# 45 McLaren St

## North Sydney

Response to Council RFI

February 2024

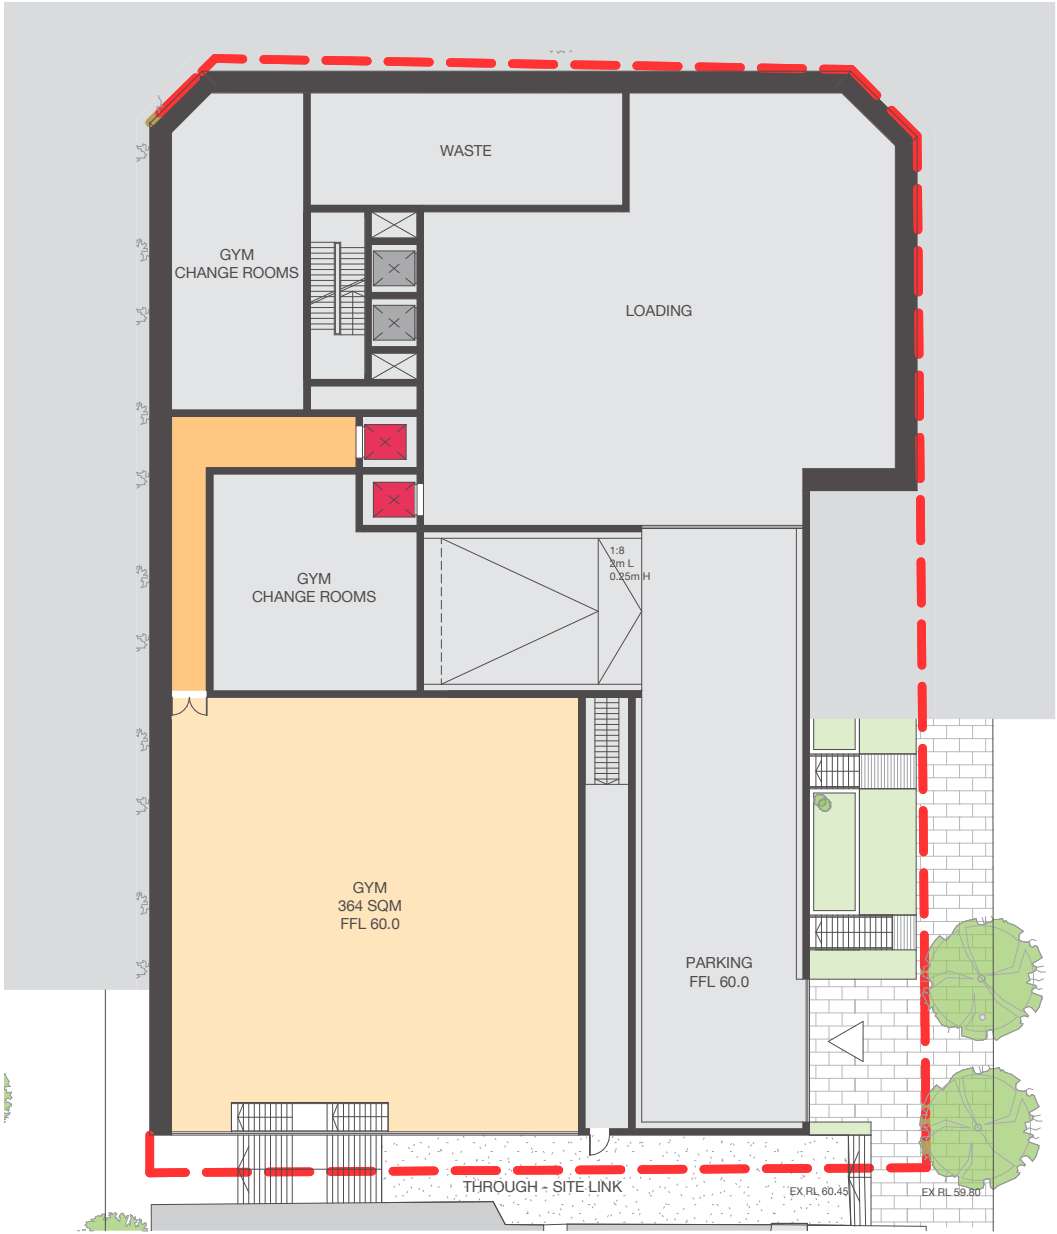
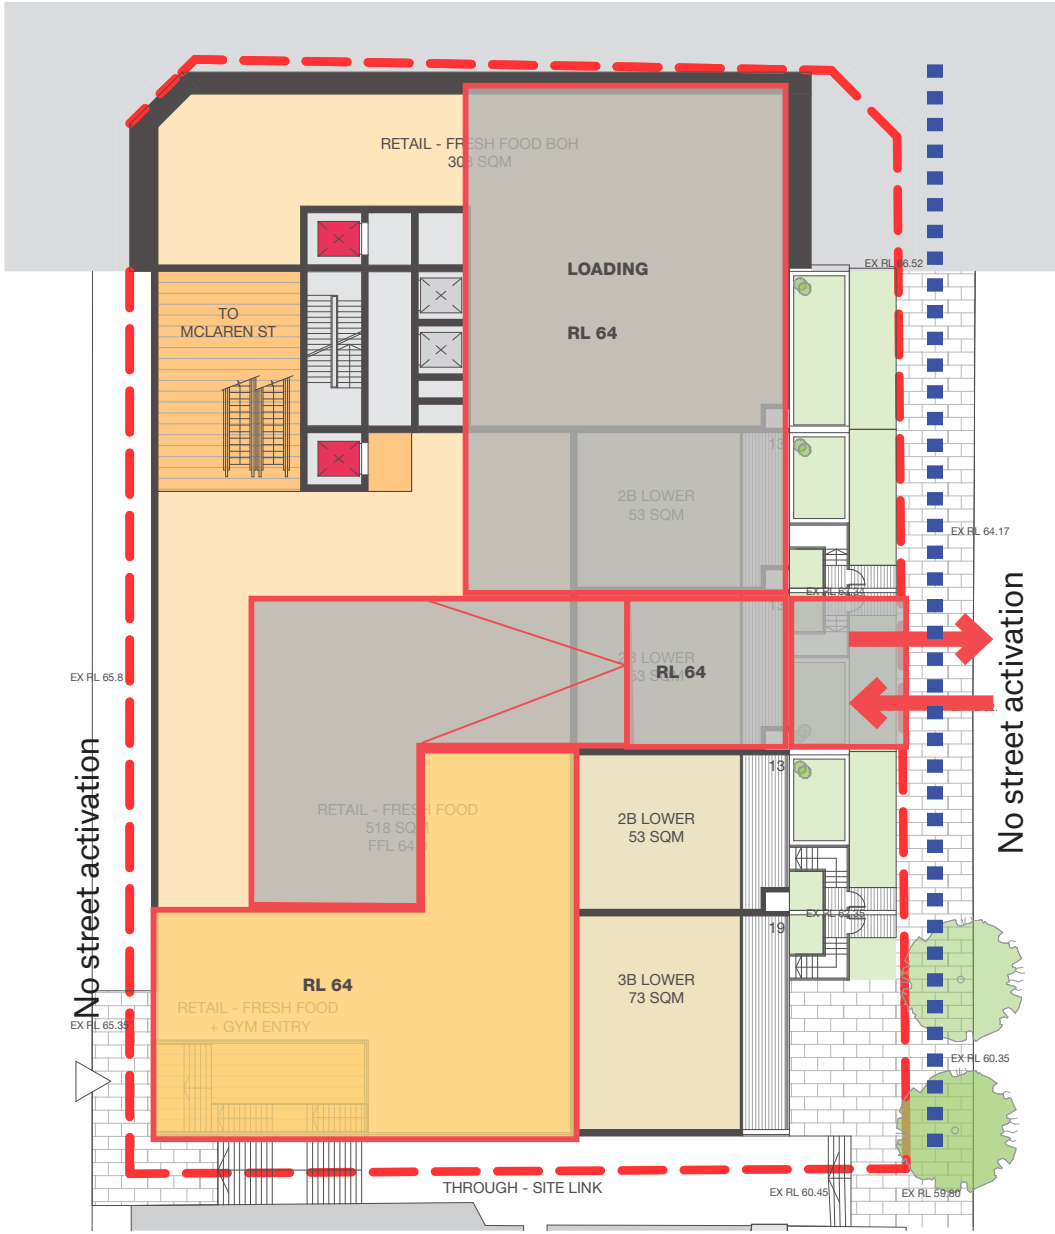
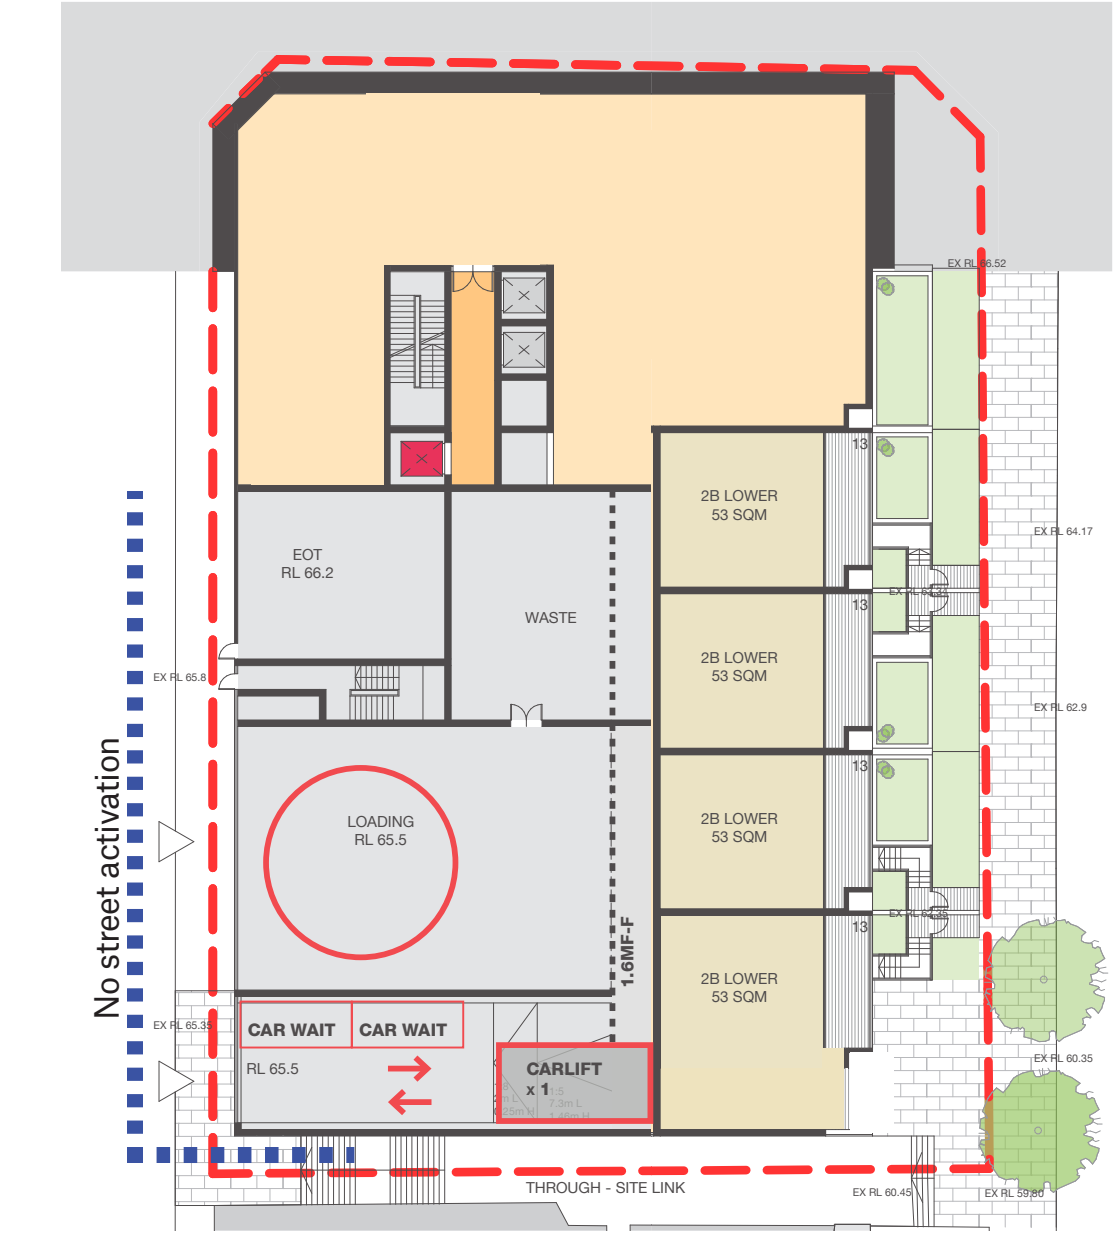
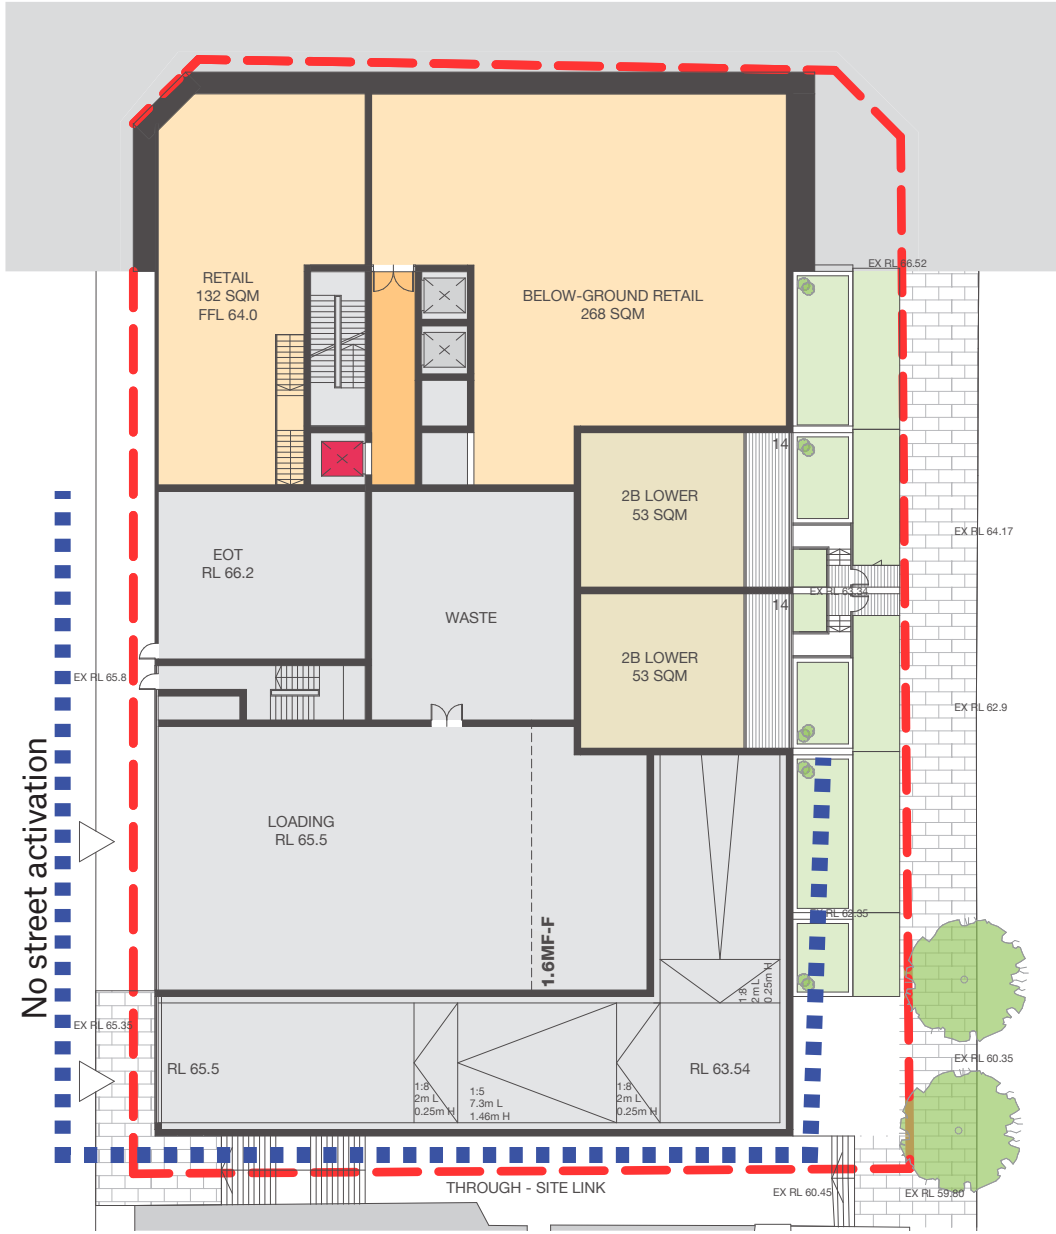
*Council has raised concern on the proposed driveway location and its the potential impacts on T10 and T11.*

*A revised application to include **diagrams** and **commentary** demonstrating options considered for vehicle access and **why the proposed option was selected***

### Harnett St Access ❌

- Significantly reduces activation on Harnett St and through-site link.
- Restricts passive surveillance.
- Negative impact on ability to achieve viable commercial tenancies. (approx. 700m<sup>2</sup> of commercial)
- Loss of residential activated frontage (terrace homes) on Walker St
- Inferior response to heritage homes on Walker Street

### Harnett St Access ❌

- Significantly reduces activation on Harnett St.
- Negative impact on ability to achieve viable commercial tenancies. (approx. 1000m<sup>2</sup> of commercial)
- Car lift access may result in increased waiting times for access and queuing.
- The introduction of a loading dock and driveway entrance on Harnett Street is likely to worsen the traffic congestion, especially considering the proposed school drop-off plan for 41 McLaren Street

### Walker St Access (existing driveway location) ❌

- Loss of residential activated frontage (terrace homes) on Walker St.
- Inferior response to heritage area on Walker Street.
- Negatively impacts viability of commercial tenancies. (approx. 800m<sup>2</sup> of commercial)

### Walker St. Access (SE corner) ✅ Planning proposal/DCP

- Entering basement from lowest level of the site to minimise ramp to loading dock. Most logical carpark entry from site topography perspective.
- Site specific DCP have confirmed Walker Street as the preferred access point to basement.
- Maximise activated frontage on Walker & Harnett Street by minimising the ramp length

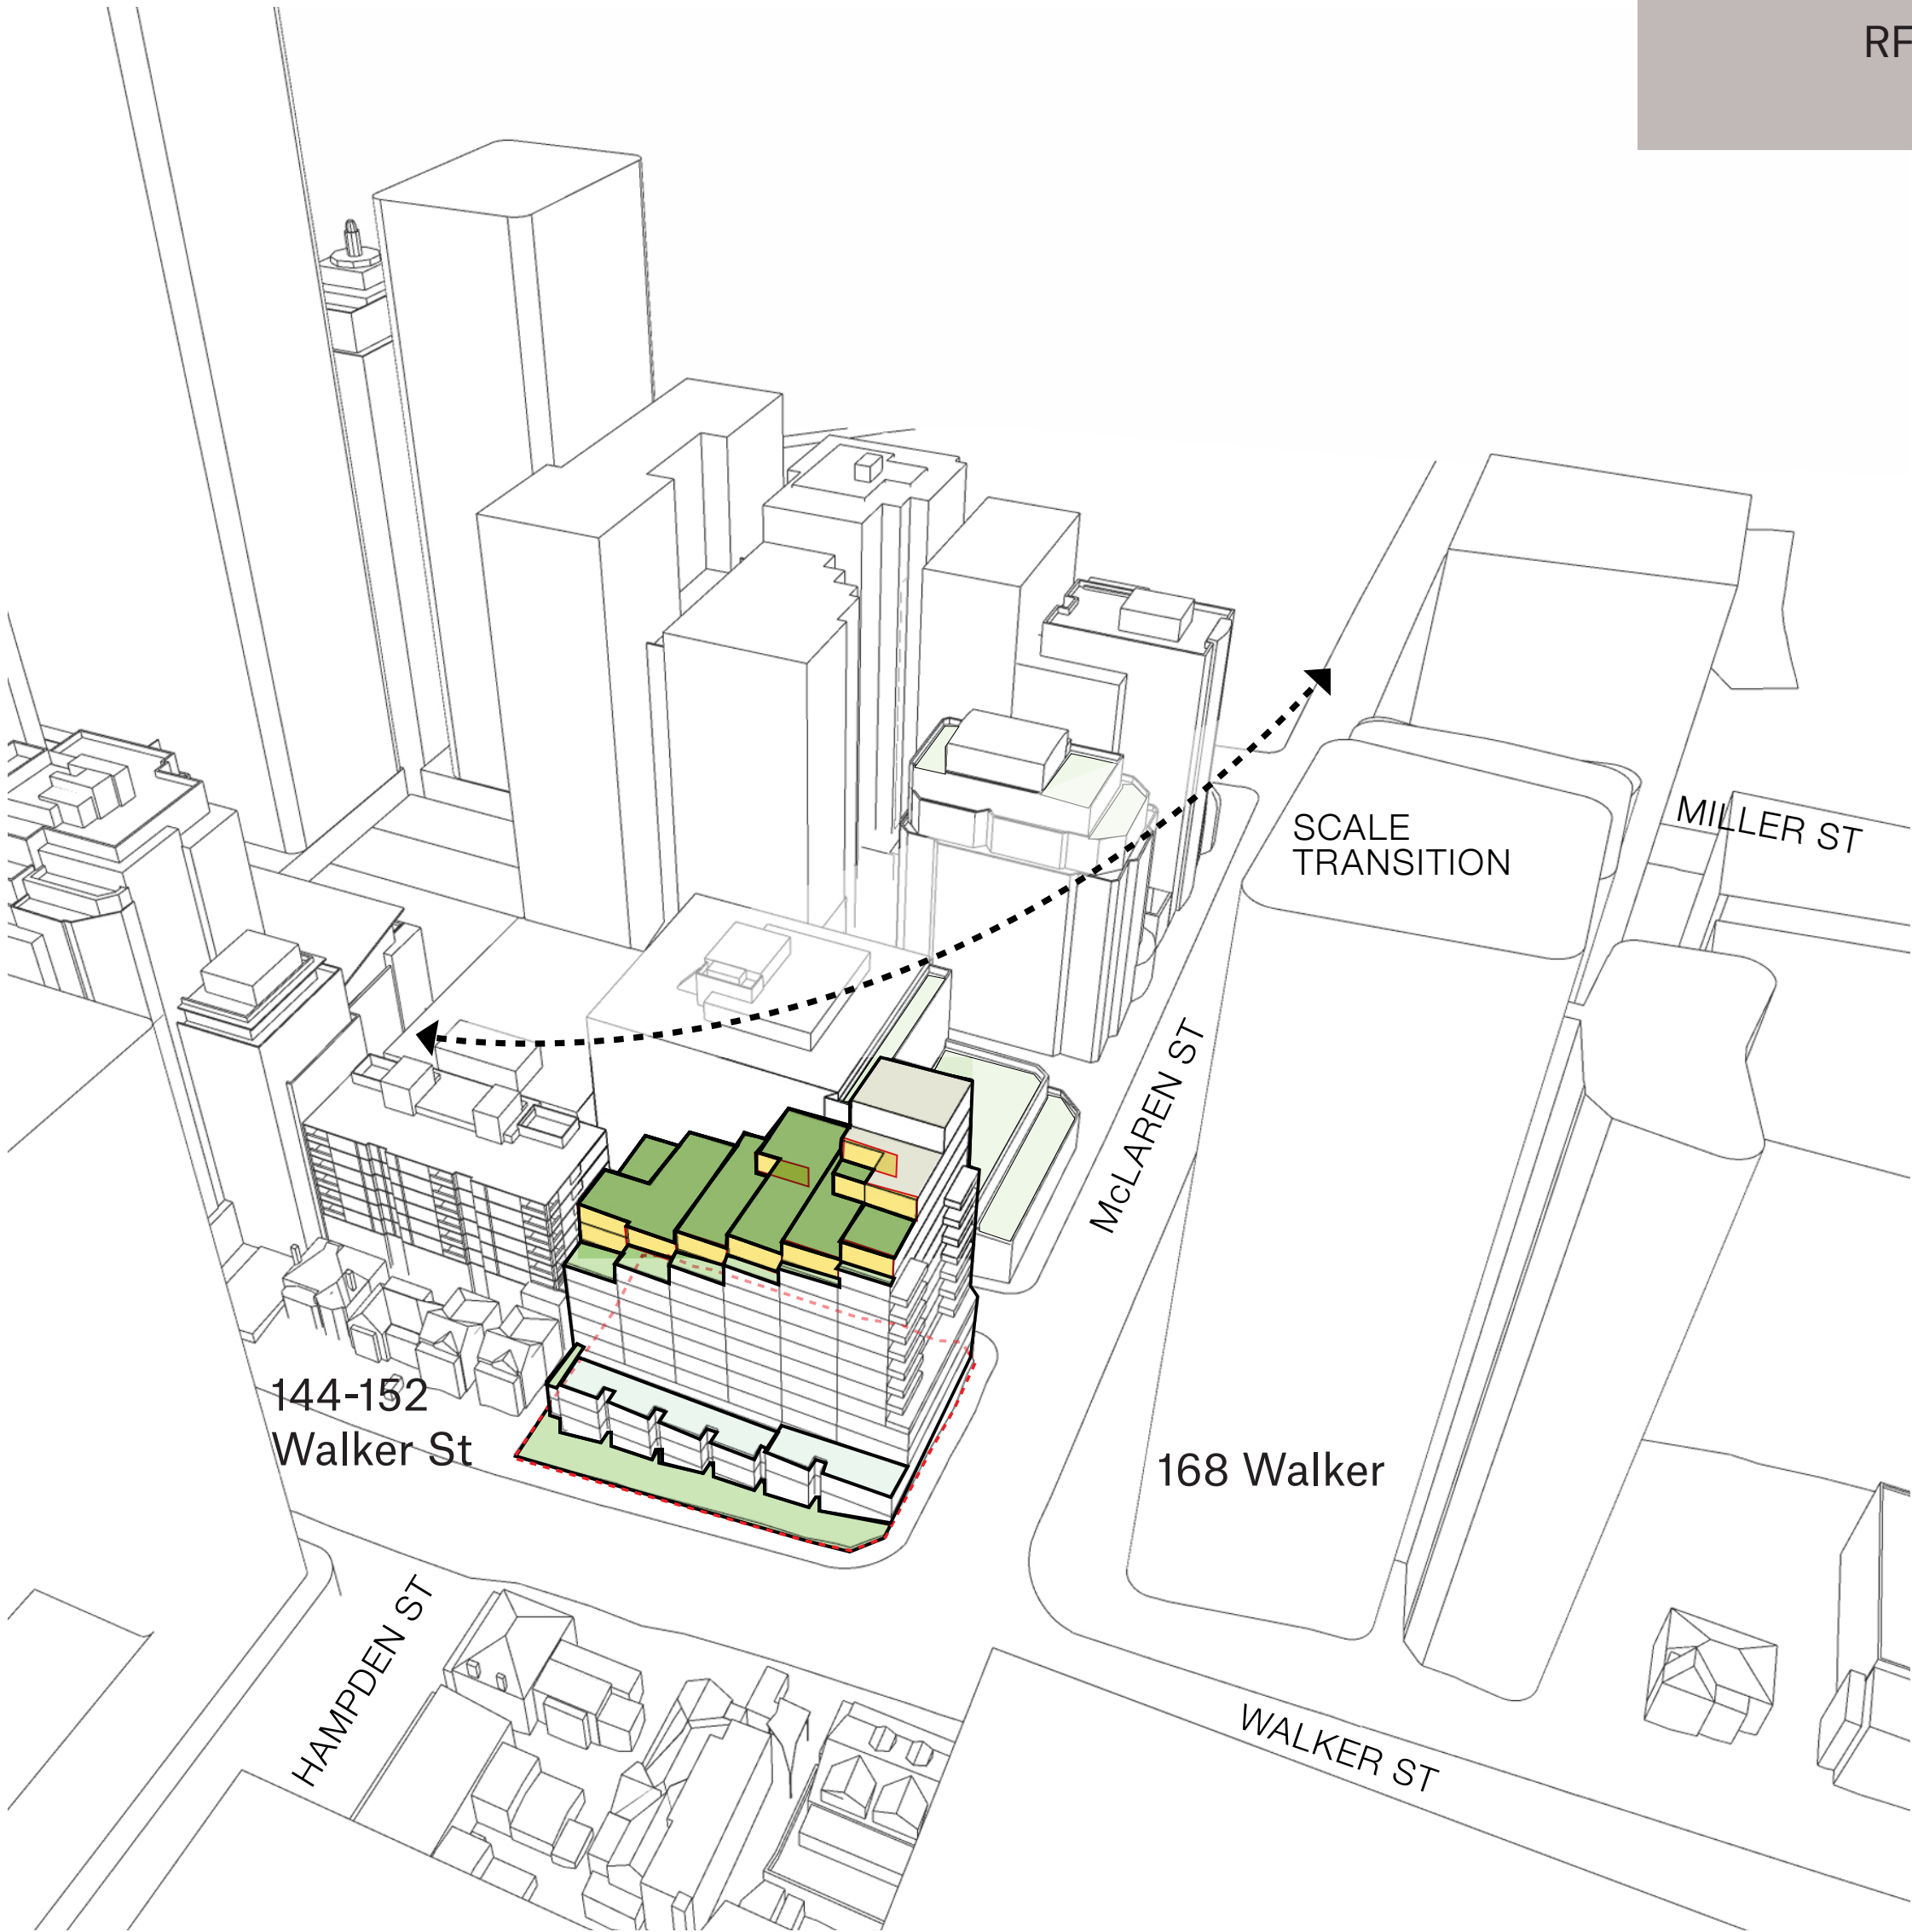
***Transition in scale*** across the site from **North to South.**

***Appropriate stepping down in the built form*** between 168 Walker and the Heritage dwelling.

***Podium setbacks*** to Walker Street and more generally the design of the ***south-eastern corner of the building*** do not appear to ***relate appropriately*** to the adjacent heritage buildings.

The stepped design of the building envelope serves to create a gradual transition in scale between 168 Walker and the heritage dwelling group at 144-152 Walker Street. This design approach not only aligns sympathetically with the existing scale transition but also ensures necessary solar access for the future Ward St. Precinct Plaza.
